CLEVELAND NATIONAL FOREST POWER LINE REPLACEMENT PROJECTS

MINOR PROJECT REFINEMENT REQUEST FORM

Date Submitted:	05-06-19	Request #:	032
Date Approval Required:	06-14-19	Landowner:	XXX
APN:	XXX-XXX-XX		
Refinement from (check all that apply):			
<input type="checkbox"/> Mitigation Measure	<input type="checkbox"/> APM	<input checked="" type="checkbox"/> Project Description	<input type="checkbox"/> Drawing <input type="checkbox"/> Other
Identify source (mitigation measure, project description, etc.):			
<p>Table B-2: Summary of Applicant's Proposed Power Line Replacement Projects of the Final Environmental Impact Report/Environmental Impact Statement (EIR/EIS) lists the maximum height for poles on Circuit (C) 440. The information in this Minor Project Refinement (MPR) request discusses the height increase for one pole along Phase I Overhead of C440 that is above the maximum pole height described in the Final EIR/EIS. A brief description and justification of the refinement is provided on page 2 of this MPR request.</p>

**Attachment B:
Pole Exceeding the Maximum Height
Phase I Overhead of C440 Map 1 of 1**

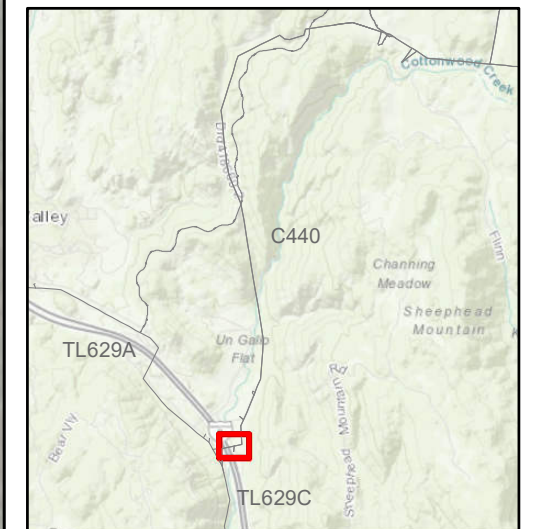
Describe refinement being requested (attach drawings and photos as needed):				
Pole P40001 will be approximately 65.5 feet above ground level, which exceeds the 62-foot maximum height described in the Final EIR/EIS for poles on C440 by approximately 3.5 feet. Because just the height of the pole is changing, the pole is only analyzed in the Visual Resources section of Attachment A: Minor Project Refinement Request Screening Form. The location of Pole P40001 is displayed in Attachment B: Pole Exceeding the Maximum Height.				
Provide need for refinement (attach drawings and photos as needed):				
The height of Pole P40001 was slightly increased in order to maintain power line height clearances for a long span over Interstate 8.				
Date refinement is expected to be implemented:		06-17-19		
Resource Agency Coordination				
Resource Agency	Name	Action Required	Date	Documentation (see attached if yes)
